<b>HYUNDAI</b>   NEW THINKING. NEW POSSIBILITIES.  <b>Technical Service Bulletin</b>		GROUP	NUMBER
		<b>AUTOMATIC TRANSMISSION</b>	<b>13-AT-012-2</b>
		DATE	MODEL
		<b>OCTOBER 2013</b>	Tucson (LM), Santa Fe (CM/AN/NC), Sonata (YF/YF HEV), Elantra (UD/MD/GD/JK), Accent (RB), Azera (TG/HG), Veloster Turbo (FS)
<b>SUBJECT:</b>	<b>AUTOMATIC TRANSAXLE (6-SPEED) OIL TEMPERATURE SENSOR DTC P0711, P0712 &amp; P0713</b>

*This TSB supersedes bulletin 13-AT-012-1 to add Op Codes.*

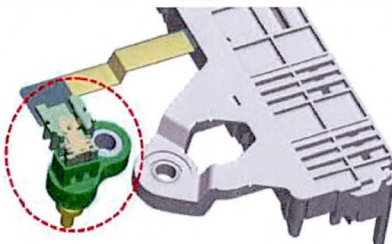
The oil temperature sensor has been integrated with the internal harness from early March, 2013. The oil temperature sensor is not available separately for these models.

Previous (separate parts)	New (integrated parts)
Oil temperature sensor and internal harness
